Product Change Notice (PCN)

Subject: [Change of tray vendor for UPD720202]
Publication Date: 6/8/2022
Effective Date: 7/31/2022

Tray change property comparison

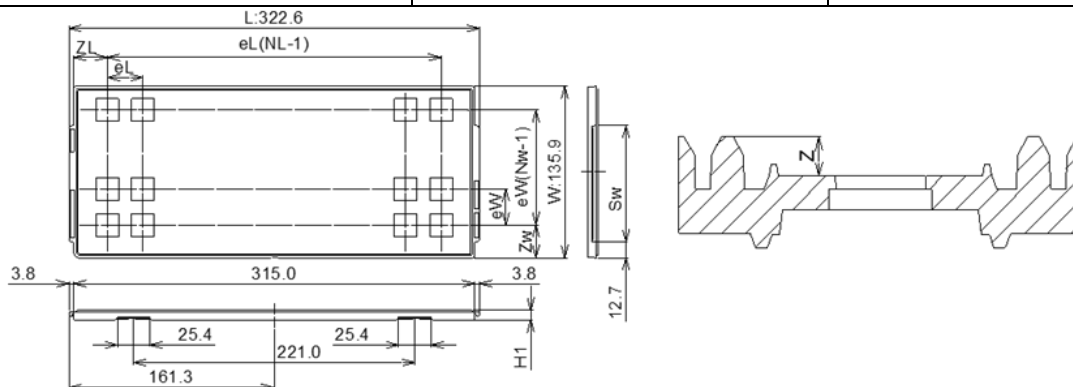
UPD720202 has two types of trays, one for ATX Semiconductor (Shanghai) assembly products and the other for Greatek assembly products. This time, we will change the tray for assembly products of ATX Semiconductor (Shanghai). There is no change in the tray for Greatek assembly products.

Before Change	After Change
P/N	JT50070701-01	180085A
Vendor	ASEKH	Zhishun
Position dimension of cells (mm)	Z	1.8
	Zw	10.35
	ZL	10.00
	eW	12.80
	eL	11.80
	Sw	92.1
Thickness (mm)	H1	7.62
Number of cells	Nw	10
	NL	26
Maximum storage No. IC/Tray	260	260
Material	PPE	PPE
Heat resistant temperature	150°CMax	150°CMax
Surface resistance	$\geq 1 \times 10^5 \sim 1 \times 10^{12}$ ohm/sq	1X104 ~ 1X1010 ohm/sq

Tray vendor for UPD720202 assembled at ATXSH will stop production, and we will change tray vendor.

Tray cell size is the same before and after change, and there is no impact on Fit, Form, Function, Quality & Reliability.
